Noyac Bay

Suite 411

SUITE 411
ORIGINAL LAYOUT
INVENTORY SUITE

NEW PLAN

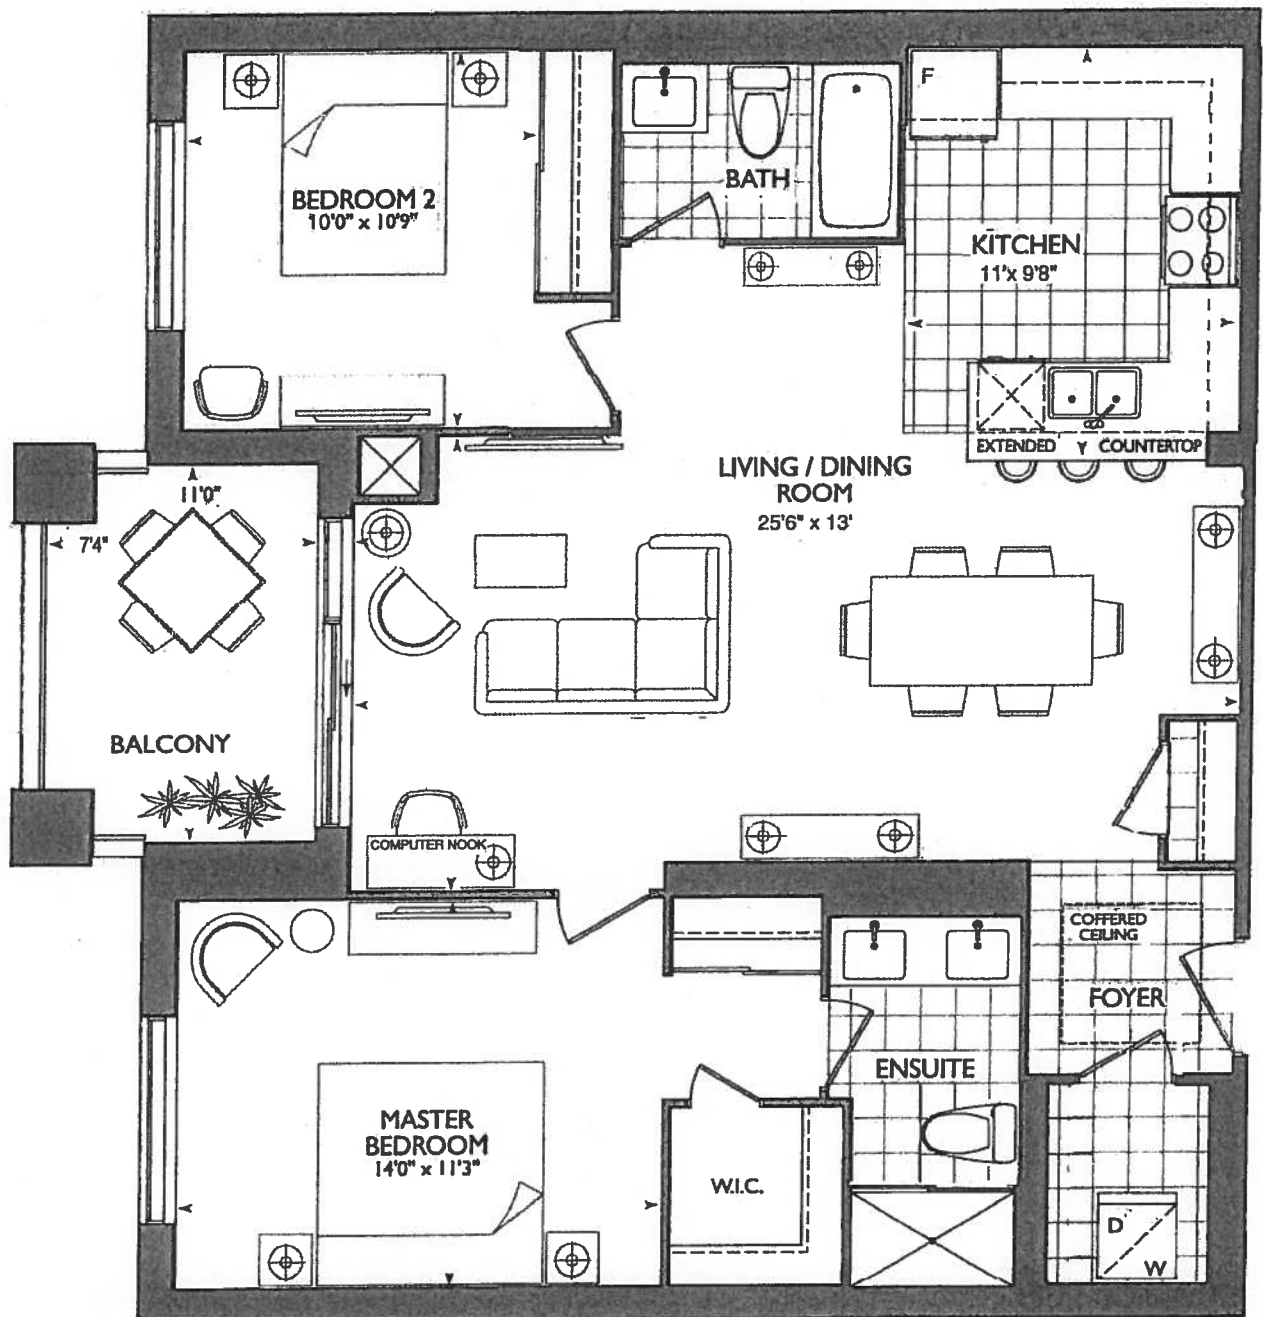
-REMOVED DEN

-REVISED KITCHEN

***REVISED LAUNDRY DOOR SWING & ENSUITE WALL AS PER THIS BROCHURE**
